TOWN OF NISKAYUNA
Planning Board and Zoning Commission
Agenda
October 3, 2022
7:00 PM

TOWN OF NISKAYUNA
Planning and Zoning Commission
Hybrid Meeting
Meeting Minutes
September 12, 2022

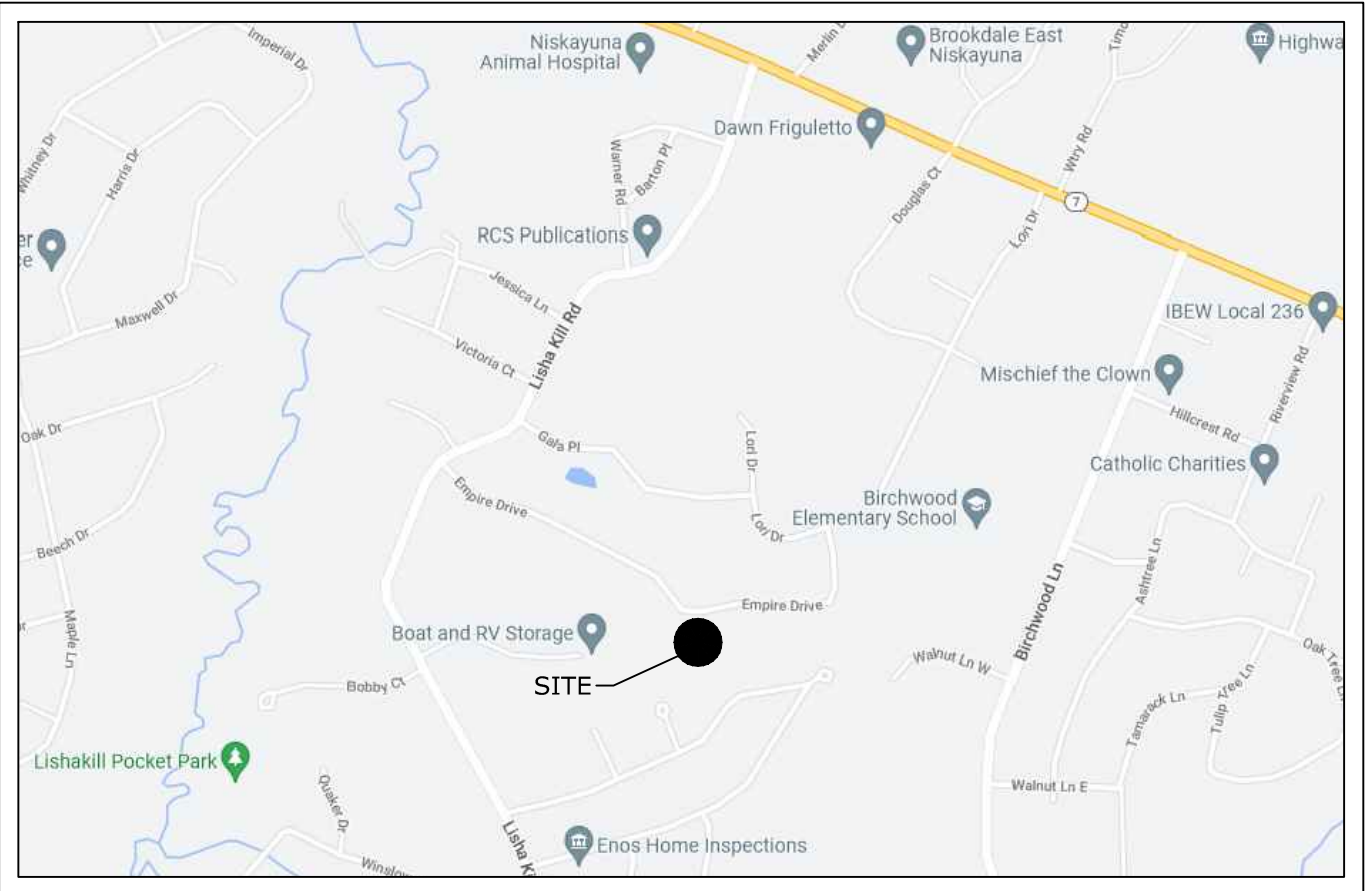
Mr. Joralemon provided a revised site plan drawing dated 8/10/22 that includes the requested information. The easement provided is 8 feet however and should be a minimum of 12 feet (2 feet on each side of path for construction and maintenance).

9/12/22 Planning Board (PB) meeting – Mr. Joralemon presented a revised site plan drawing (marked R2 dated 9/6/22) and noted the changes that had been made per the request of the PB. A discussion regarding drainage ensued. Chairman Walsh asked that a written drainage plan be prepared. He noted that a full SWPPP is not necessary but a written plan documenting how drainage is being addressed is necessary. He added that the plan should also include the impact of snow storage and a Town Designated Engineer (TDE) will review the material. A Board member recommended that the site plan be revised to preserve some trees between the two proposed lots. Ms. Robertson stated that the Tree Council will walk the site.

- A 1-page drawing entitled “Layout Plan 2-Lot Minor Subdivision Empire Drive Lands N/F of Joralemon” by C.T. Male Associates dated 6/30/22 with a most recent revision of Rev 2 dated 9/6/22. A Filter Strip Treatment Area has been added to the plan to the west of the house on Lot 1. A tree buffer has also been added between the houses on Lots 1 and 2.

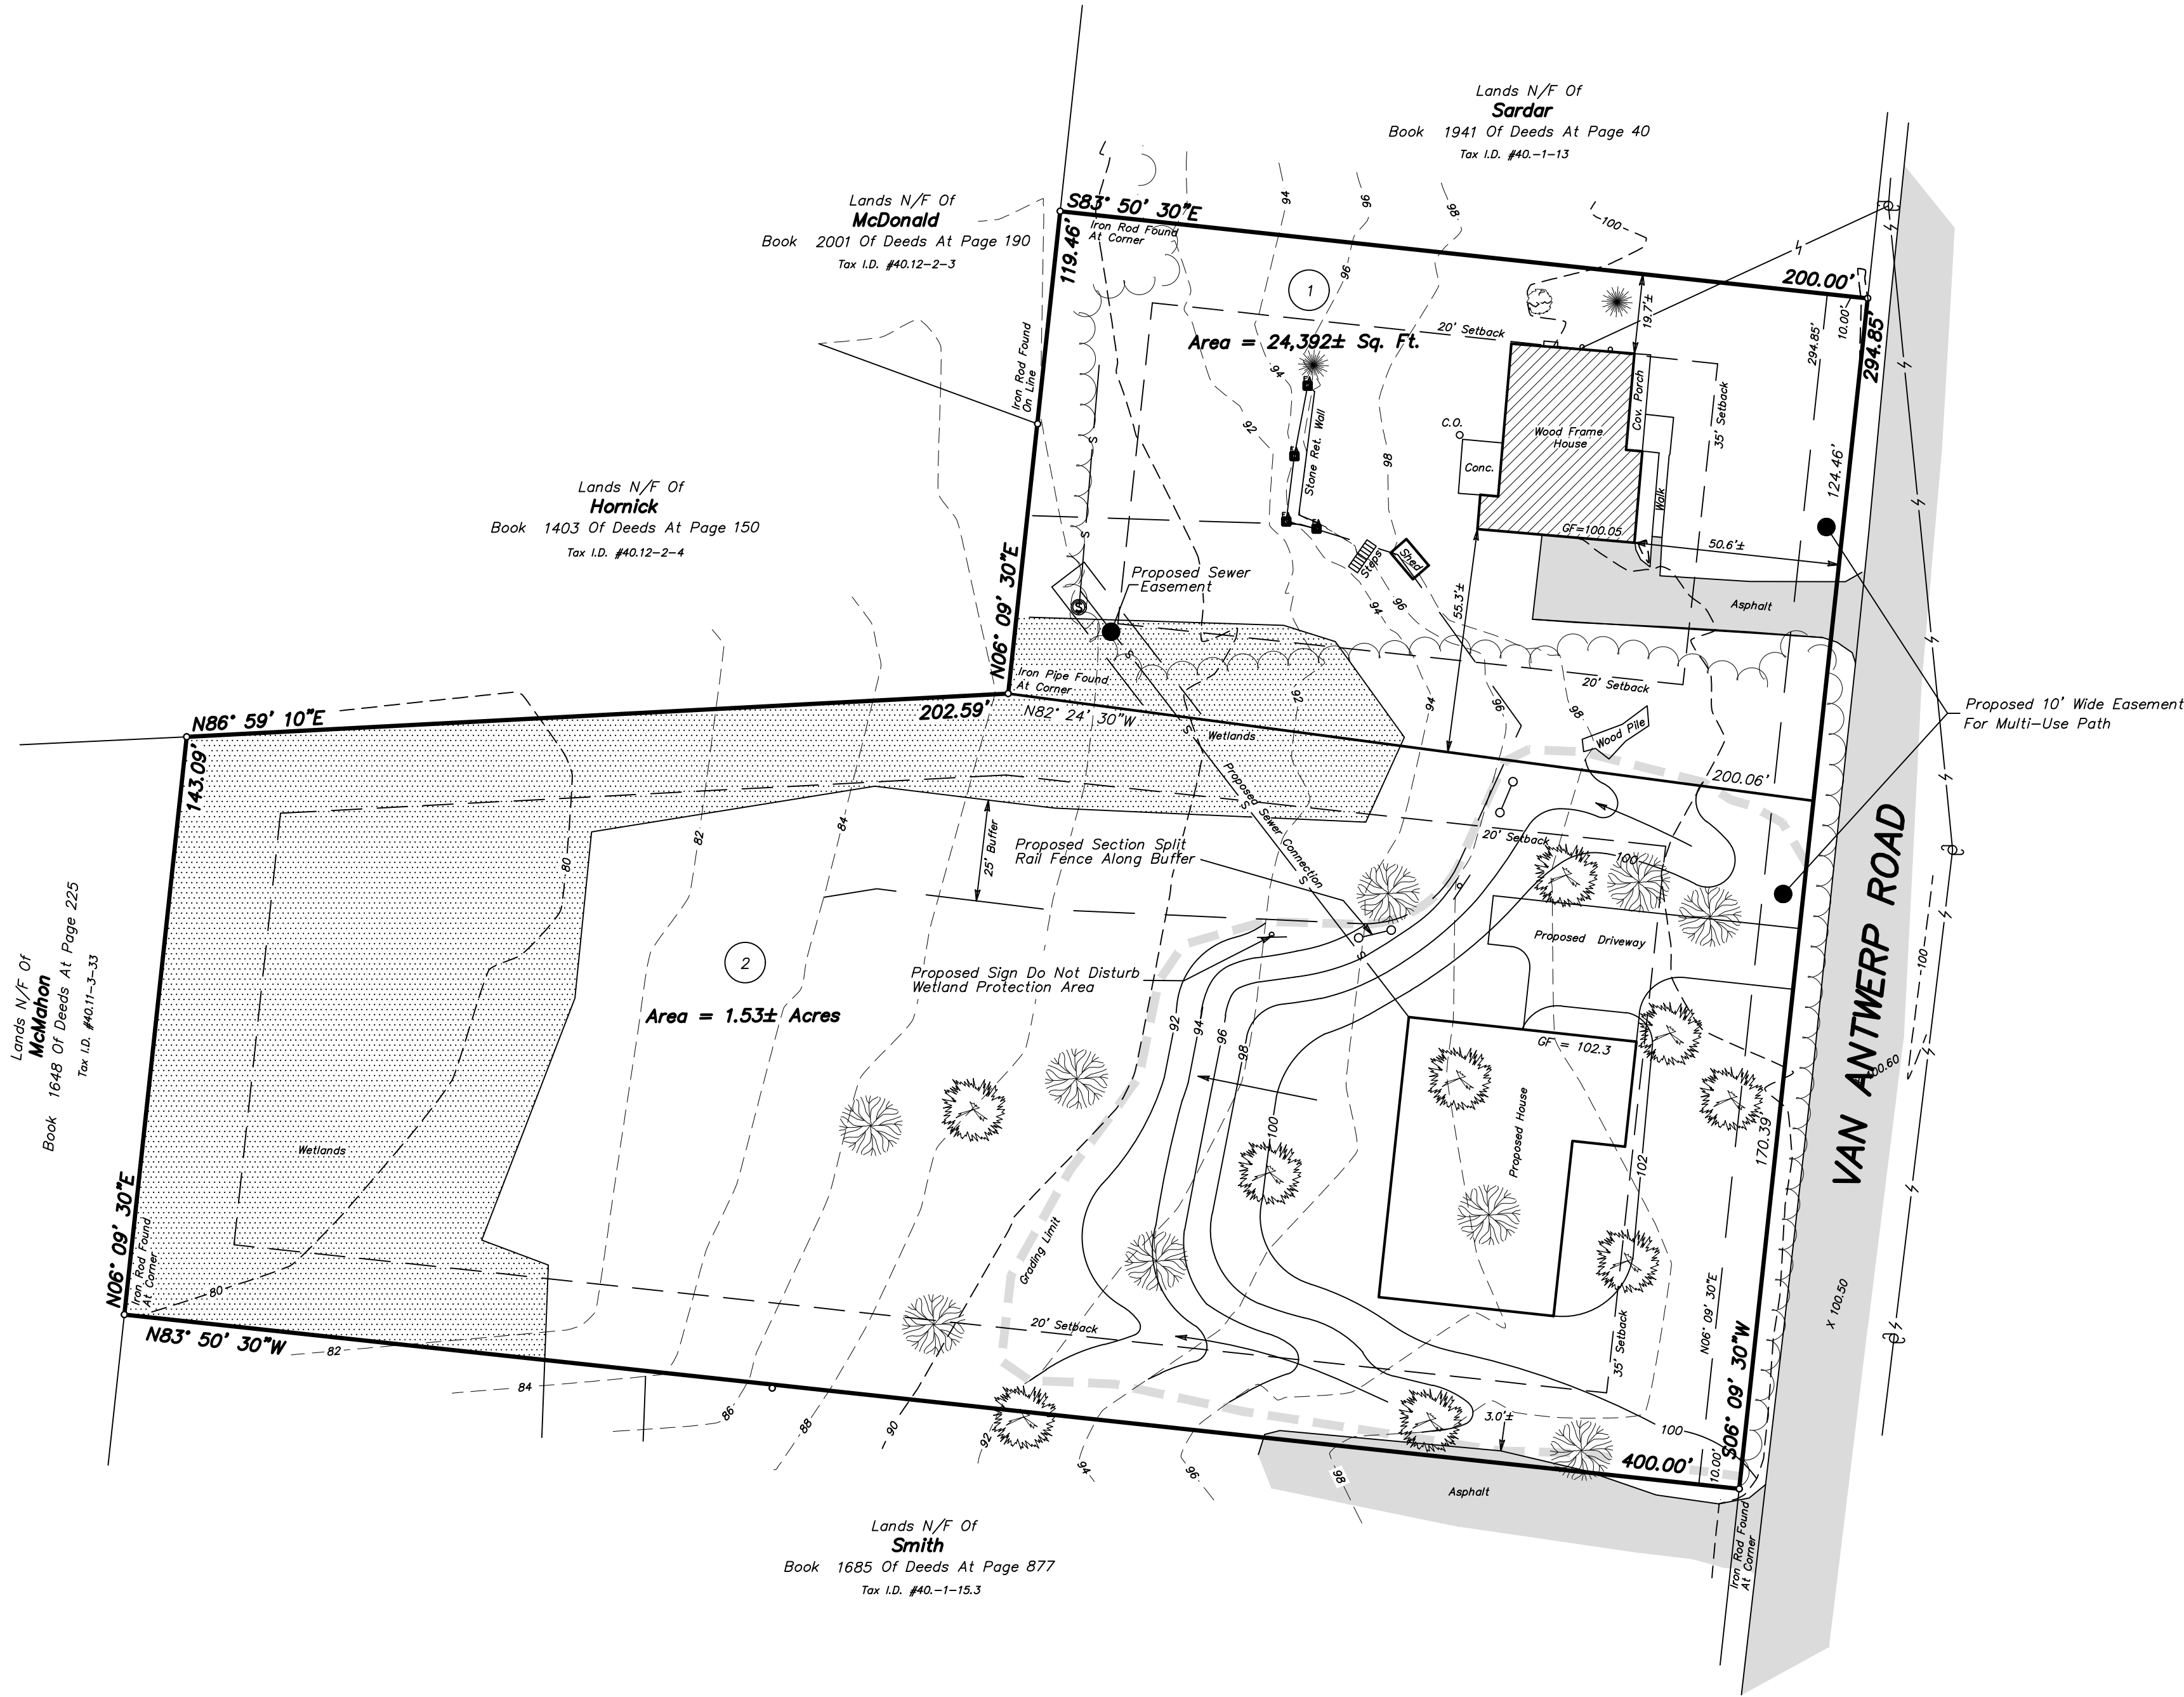
Also – the proposed ground floor of this house is 2.3 feet higher than the adjacent home to the north, and potentially even higher than that compared to the adjacent home to south. The Planning Board has heard and agreed with complaints in the past with approved in-fill homes being higher than the surrounding homes makes them look very out of character with the existing community. Areas of 4-6 feet of fill are being proposed to be added for much of the lot, especially along the south side (highlighted in blue) The Planning Department consulted with the Engineering Department on this – who also suggests requiring the proposed home foundation be lowered to more closely match the surrounding homes. This should reduce the amount of grading/filling that needs to be done around the home, help preserve more trees, and help the proposed new home blend into the neighborhood better.

Mr. Jarosz provided a revised site plan drawing identified as Rev 9/2/22. The revised drawing shows the location of approximately 19 trees on the property near the proposed limits of clearing and grading that are over 25" in diameter. Per Town Code 201-11 Land Development (B) "the Planning Board may require the developer to identify trees of value by locating them on a survey map at an average density of up to 10 trees per acre. This information shall be used by the Planning Board to determine which trees shall be preserved and so designated on approved development plans." There are several trees which are close to the edges of clearing and grading that the Planning Department recommends to be preserved (see attached map with suggestions highlighted in yellow and reduced clearing limits marked in green).
